RECEIPT DATE: 5/29/18 **ONSITE SEWAGE DISPOSAL SYSTEM**

PROPERTY ADDRESS: 3396 Jennings Chapel Road

### MEMORANDUM

RE: Marjorie's Green, Lot 2  
3396 Jennings Chapel Rd.  
Woodbine, MD 21797

7/11/18 Junction box NOT TO SCALE

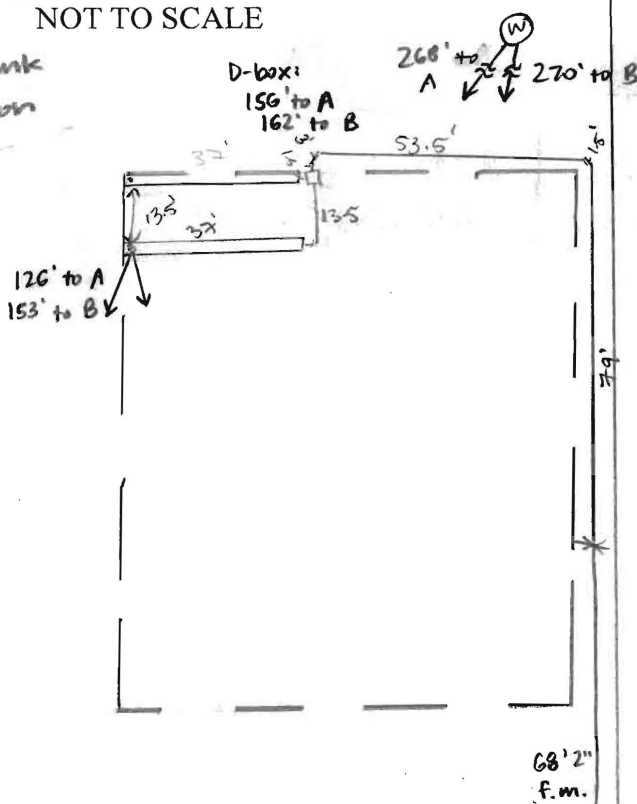
must be mounted on post outside riser. [Corrective action.] (SC)

now outside pump tank riser. [Corrective action completed.] (SC)

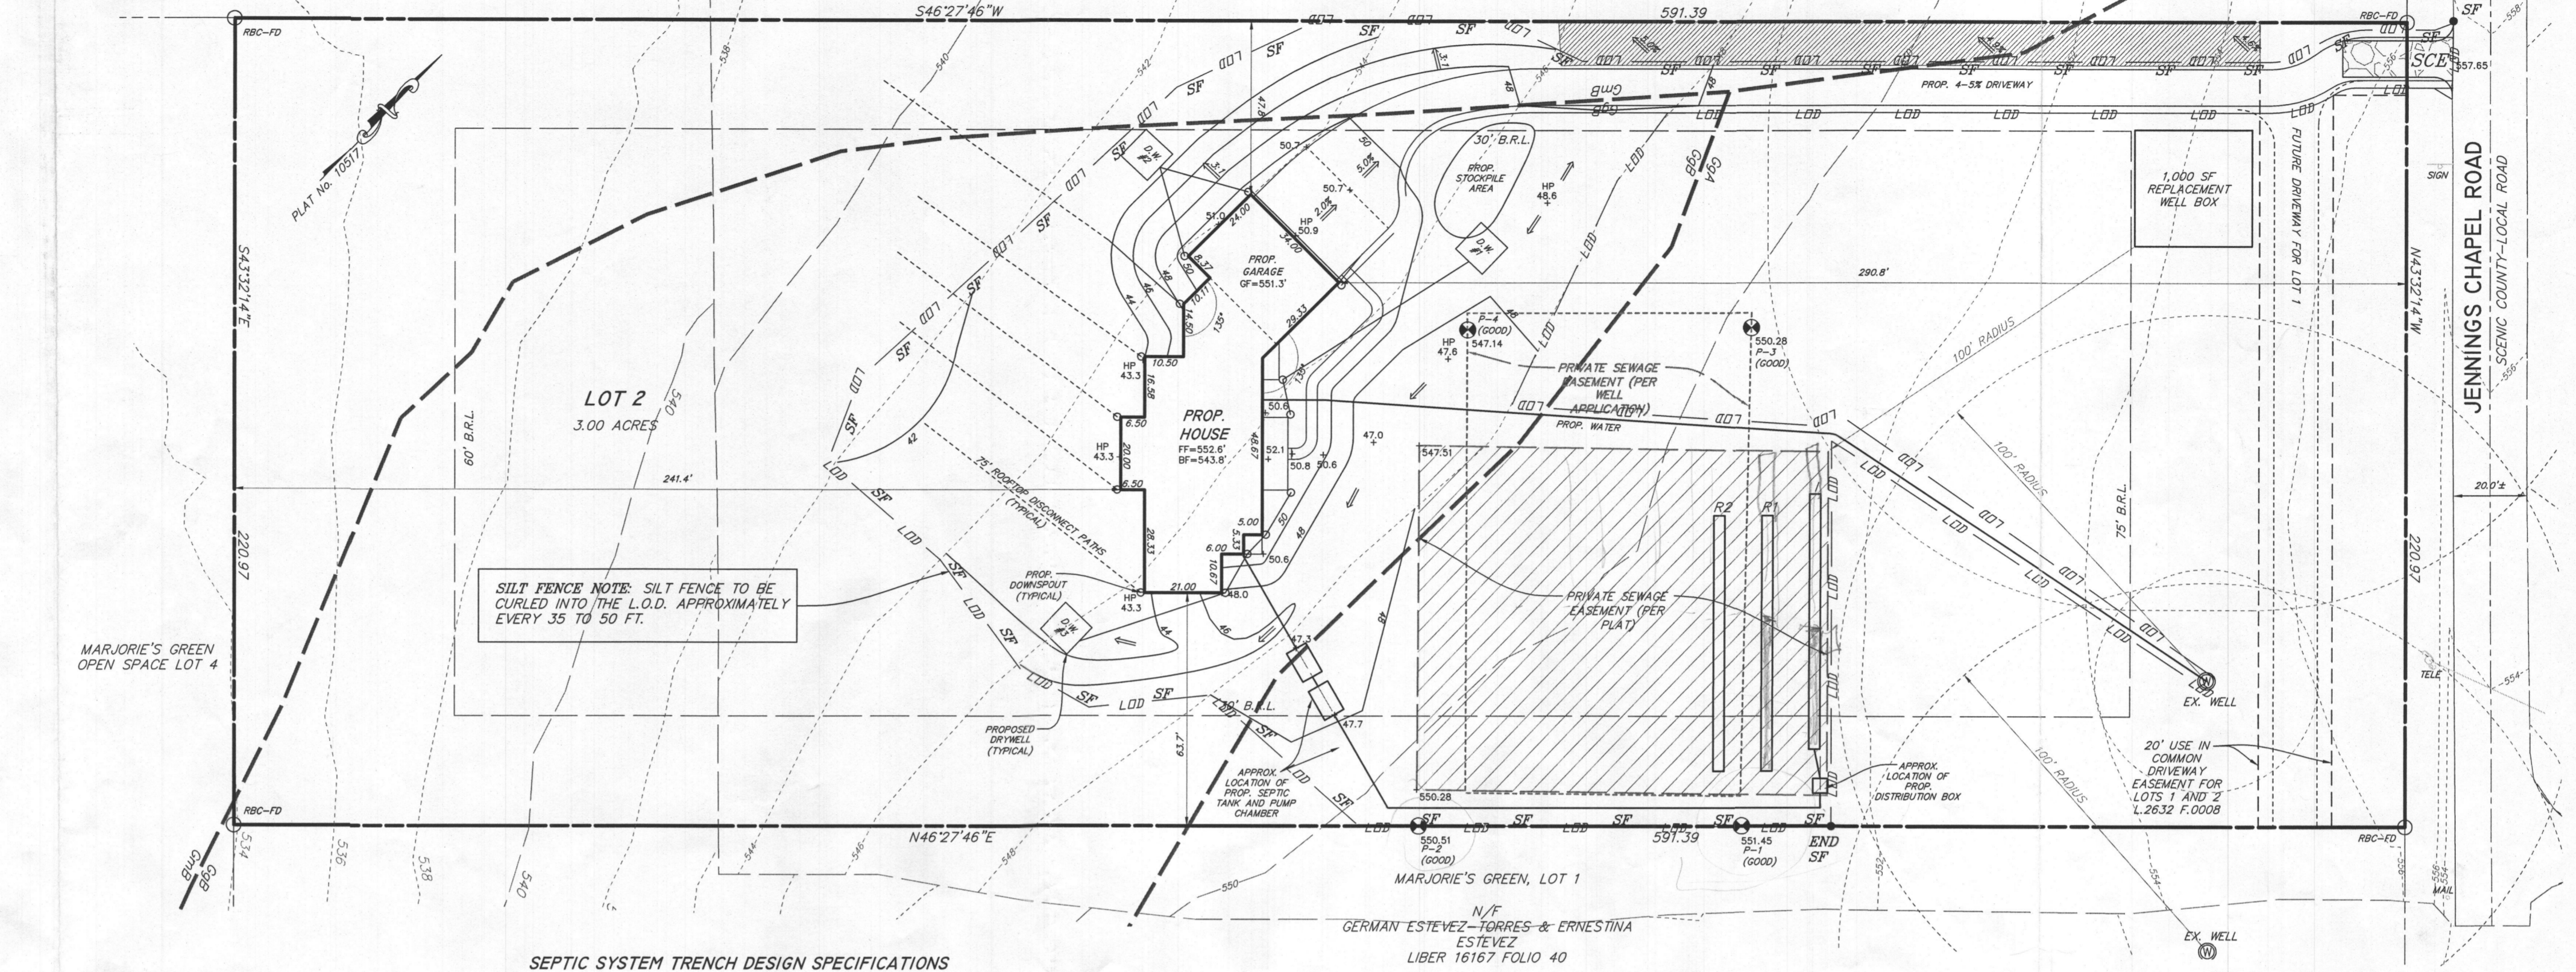
*Comment: Replacement well sites need to be added to the plan in case the existing well fails. These can be added in as two separate well sites or as one well box (must be 1,000sqft). These sites must be labeled as alt or replacement wells. If designers are pinched for space sometimes they will prefer the well box. If alternate well sites are used they must be 50' apart from other wells. These alt/replacement well sites are treated the same as existing well sites (100' arch, 30' arch, setbacks, etc...).*

*Comment: The neighboring well needs to have a 100' well arch.*

*Comment: Perc hole locations and elevations must be shown on the plan. Perc holes must be labeled to with their corresponding ID's to be able to identify them each individually. Perc holes must also be labeled as to which holes passed and which holes failed (if any).*

*Comment: The well statement in the "Septic System Notes" must include the tag number and who field located it. The tag number must also be shown on the plan.*

*Comment: The sewage disposal area (SDA) must be labeled with its sqft.*

**Response: A 1,000sf replacement well box has been added to the plan.**

**Response: Added.**

**Response: Added.**

**Response: Added.**

**Response: Added. Area has been hatched and referenced in the legend as "Private Sewage Disposal Area (See Note #12). Note #12 identifies the area as at least 10,000 SF and lists more relevant information on the SDA.**

**PLAN VIEW**  
5'5" x 3'25" x 5'3" = 149.36' x 7.48' = 1,109.73 sq ft  
MANHOLE ACCESS RISERS TO GRADE (TYP.)

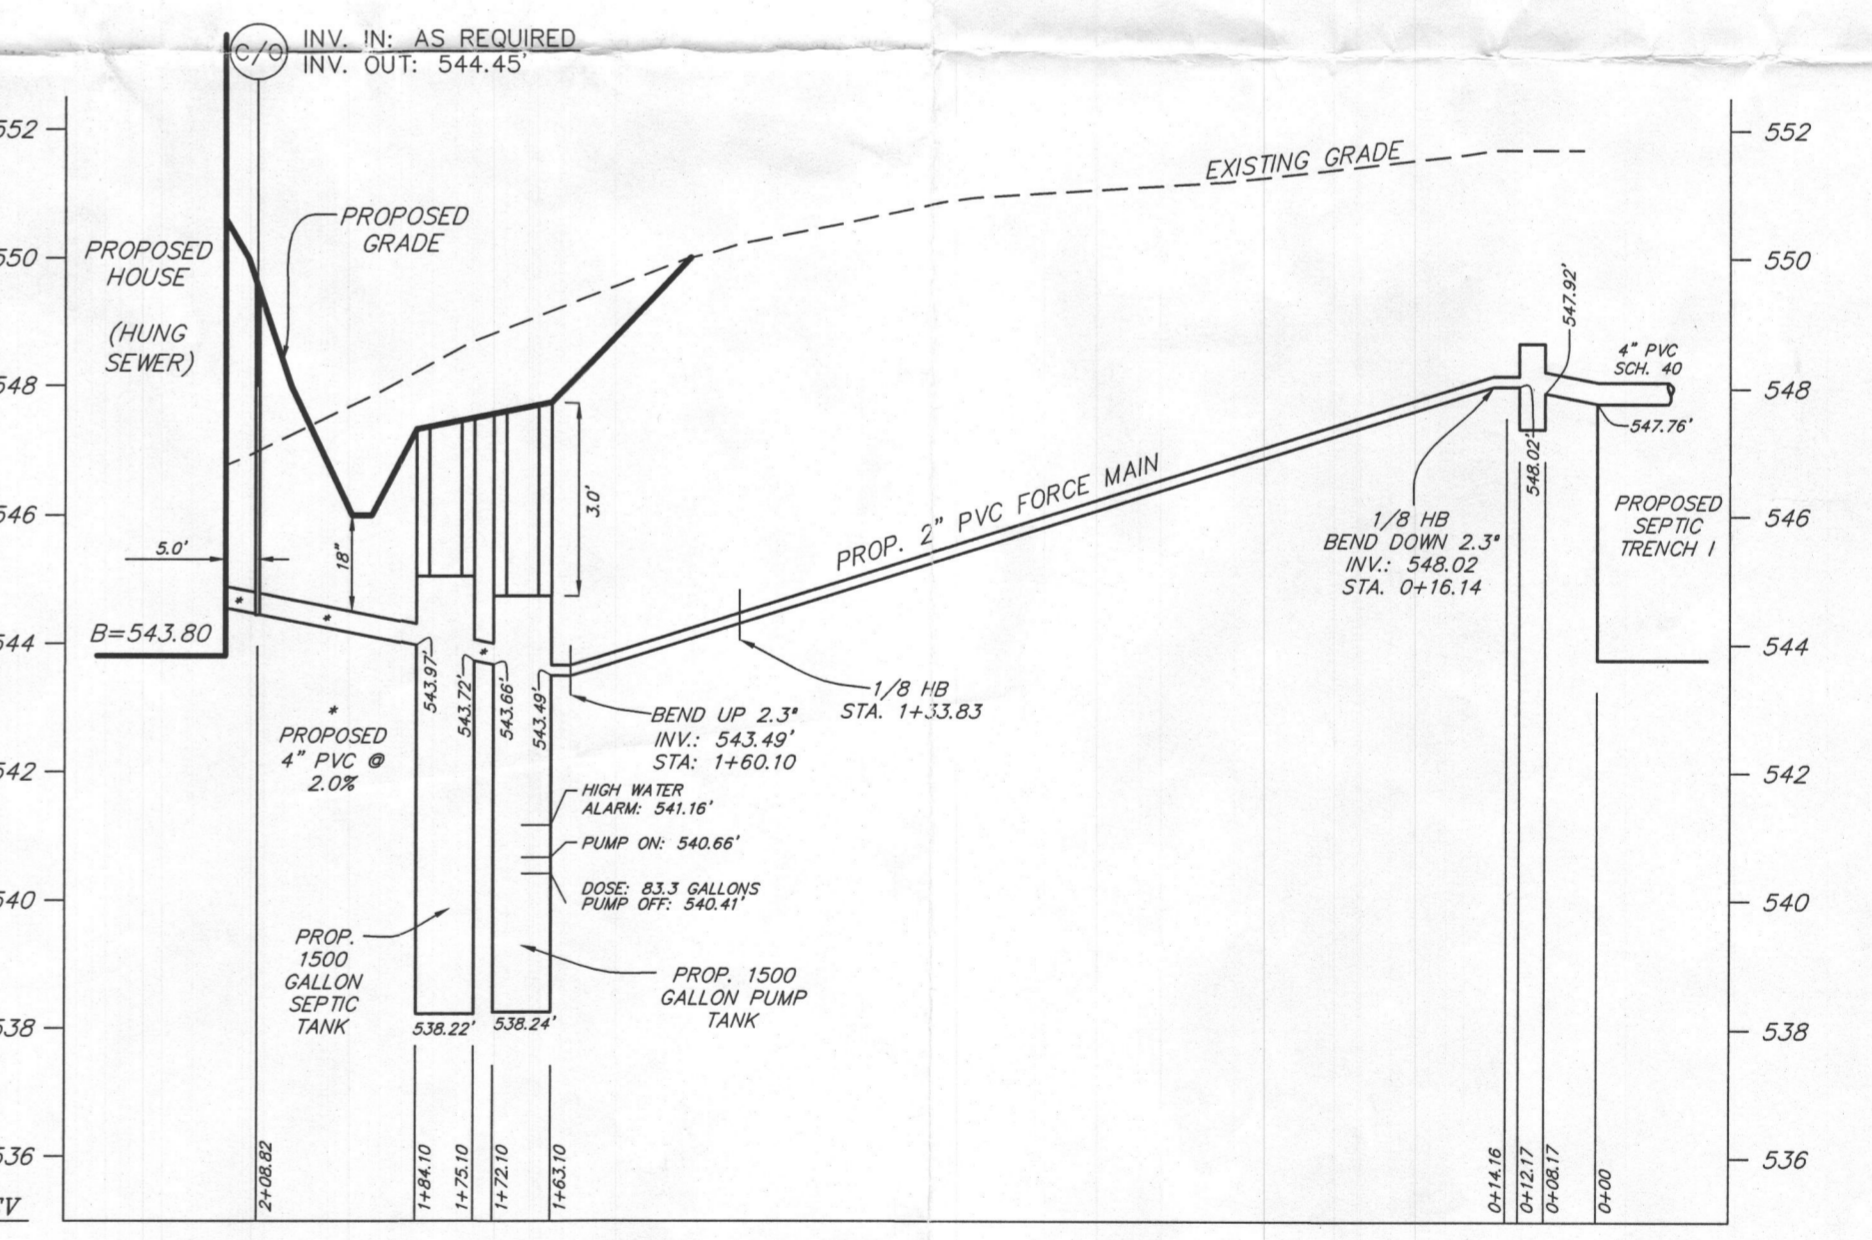
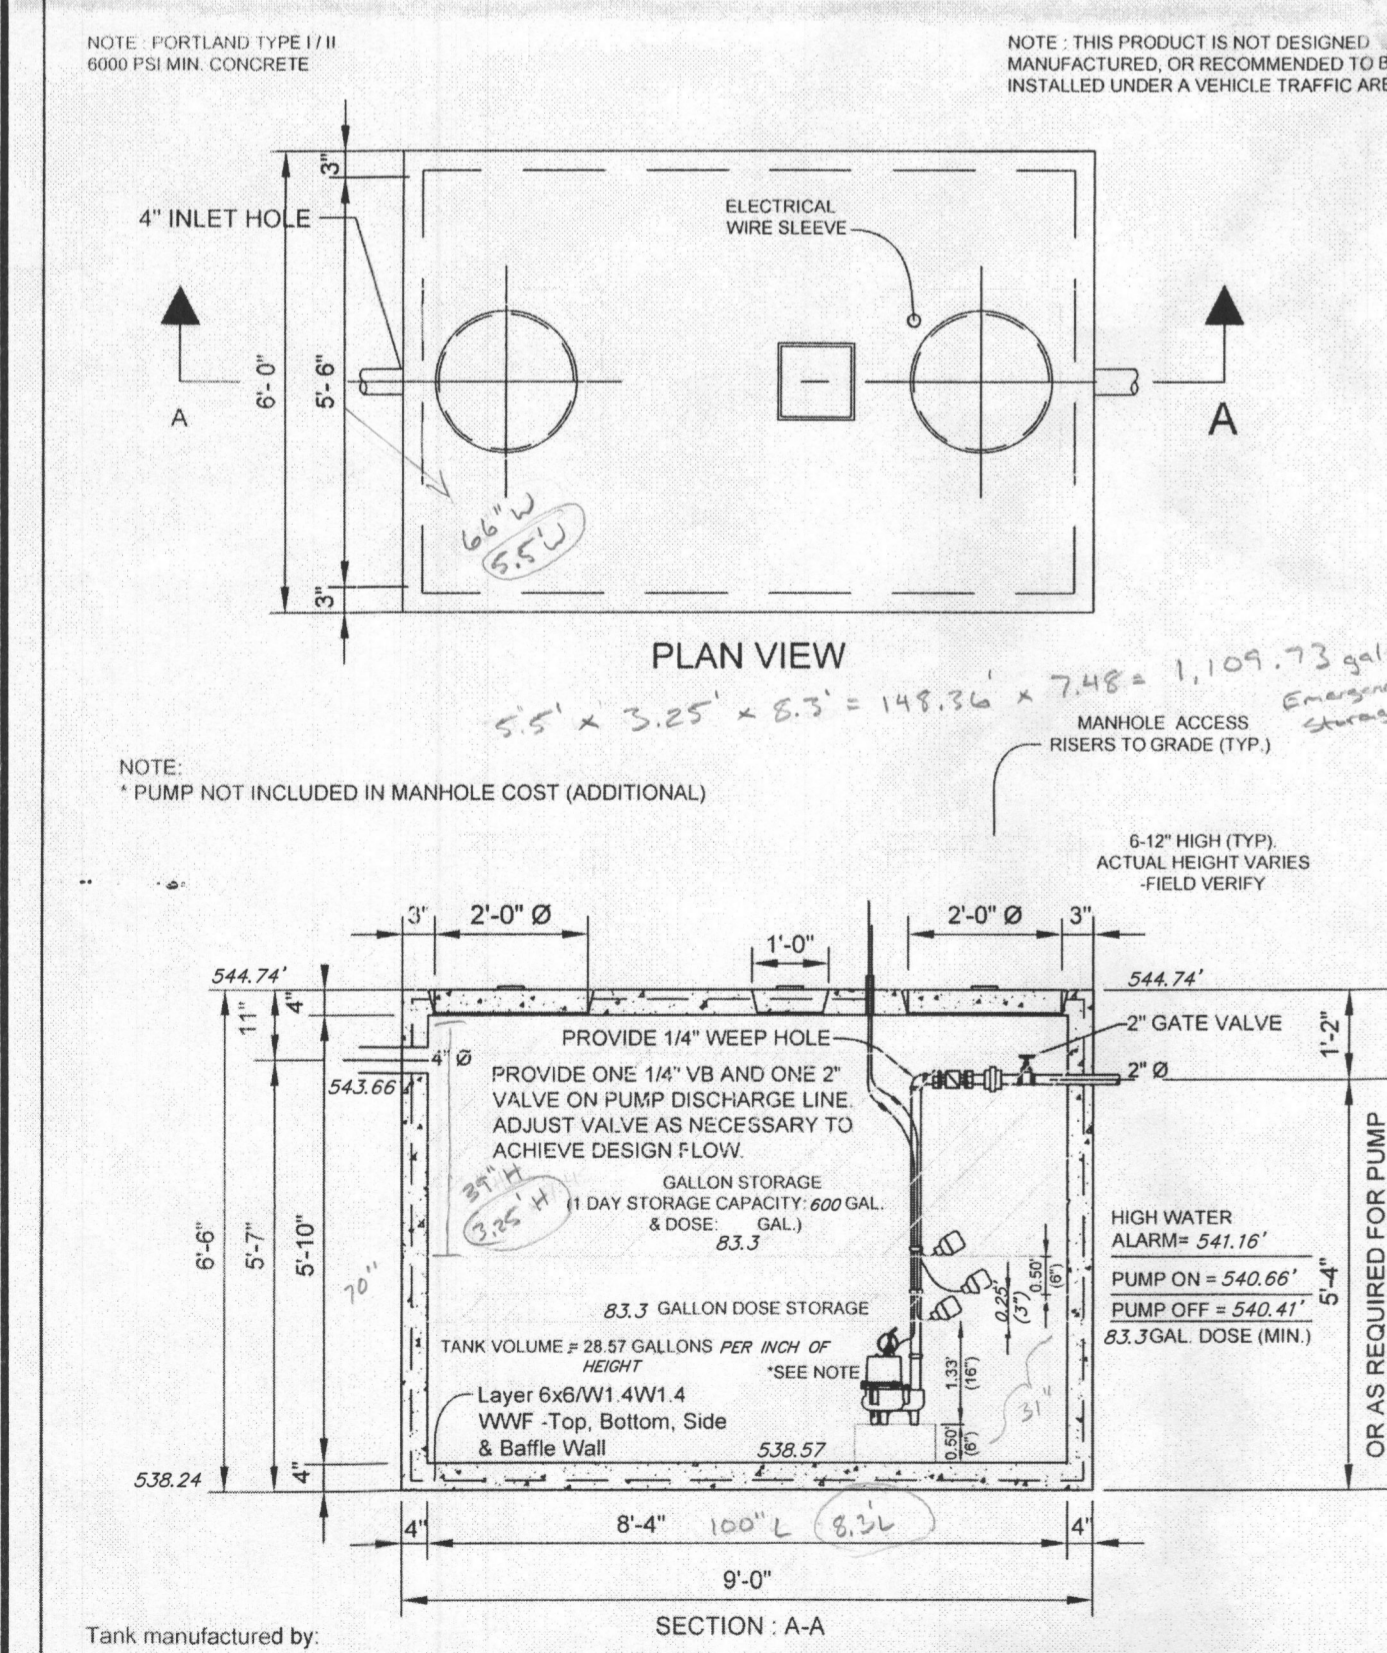
*Comment: There are conflicting statements concerning the dose (58.3gals vs. 83.3gals) in the "Plan View" of the pump tank.*

*Comment: The calculations involving the number of gals per 1 day of emergency storage in the "Plan View" section needs to be checked.*

*Comment: The calculations involving static head need to be checked as they are affecting the total dynamic head calculations. The pump graph will need to be changed as the calculations are changed.*

**Response: The Plan View has been corrected.**

**Response: The Plan View has been corrected.**

**Response: Static head, TDH, Pump Curve, and Calculations have been revised**
